ECE/TRANS/WP.29/2010/53
24 December 2009

Proposal for the 06 series of amendments to Regulation No. 83
(Emissions of M₁ and N₁ vehicles)

Submitted by the expert of the European Commission */

"Annex 3

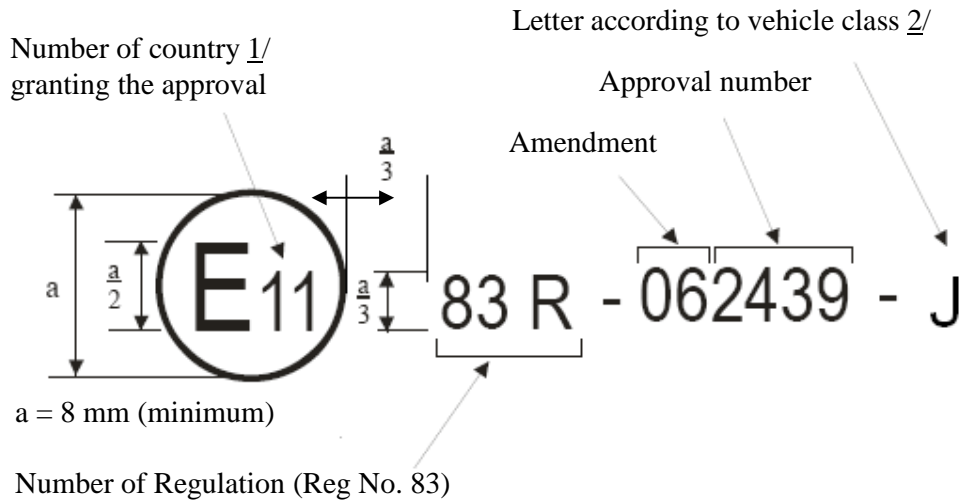
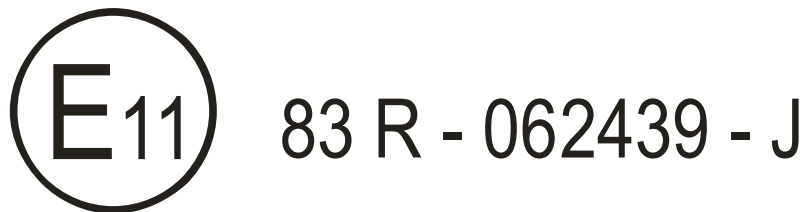
Annex 3., amend to read:

In the approval mark issued and affixed to a vehicle in conformity with paragraph 4. of this Regulation, the type approval number shall be accompanied by an alphabetical character assigned according to Table 1 of this Annex, reflecting the vehicle category and class that the approval is limited to.

This annex outlines the appearance of this mark, and gives an example how it shall be composed.

The following schematic graph presents the general lay-out, proportions and contents of the marking. The meaning of numbers and alphabetical character are identified, and sources to determine the corresponding alternatives for each approval case are also referred.

The preceding approval mark affixed to a vehicle in conformity with paragraph 4. of this Regulation shows that the vehicle type concerned has been approved in the United Kingdom (E₁₁), pursuant to Regulation No. 83 under approval number 2439. This mark indicates that the approval was given in accordance with the requirements of this Regulation with the 06 series of amendments incorporated. Furthermore, the accompanying letter (J) denotes that the vehicle belongs to vehicle category M or N_{1,I}.
